Sydney Olympic Park New High School

Architectural Response to SDRP Report

Setback to northern boundary

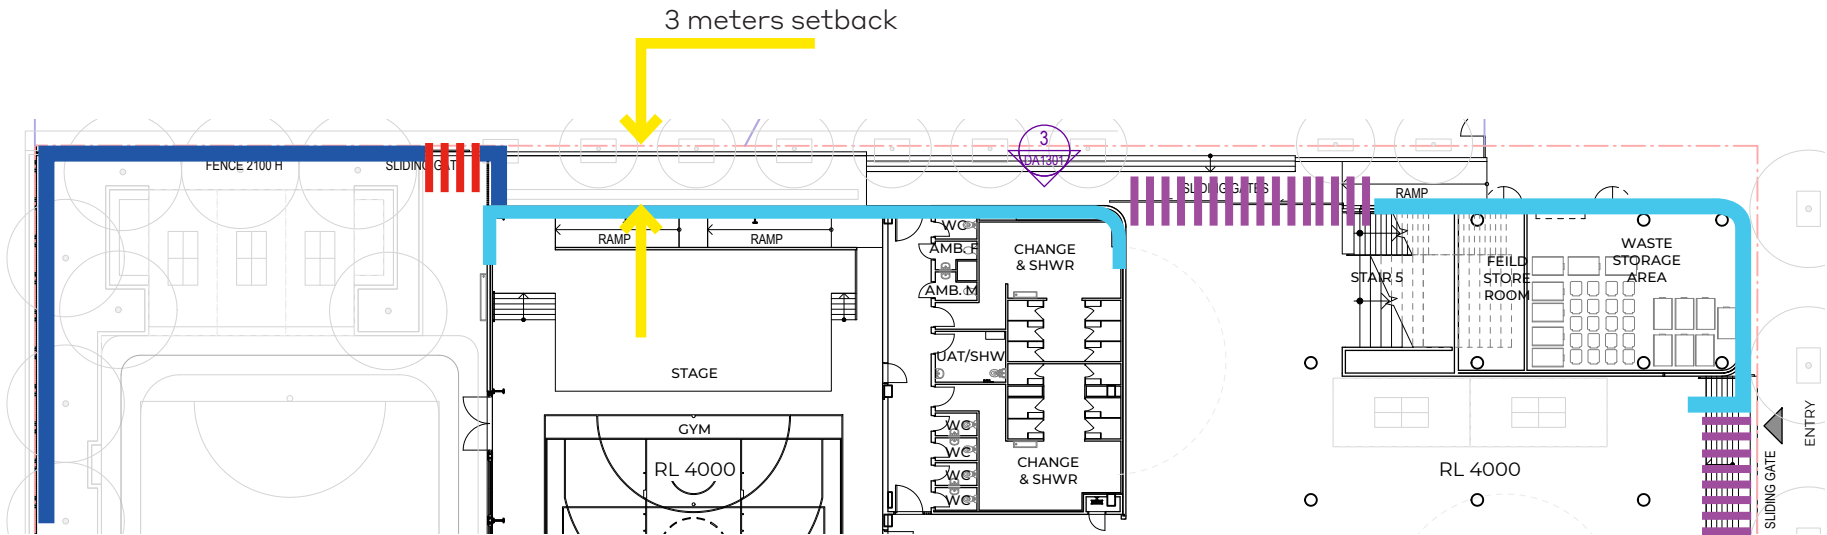
Comment: Provide an update on the northern boundary setback and any subsequent impact on available play space.

Refer to Item E8a

Urbis have added trees to the northern boundary within the setback zone with porous pavement (to address Issue item A3.2)

The reduction fo the bicycle parking has provided an opportunity to create an enhanced First Nations productive garden and passive recreation area to the play space.
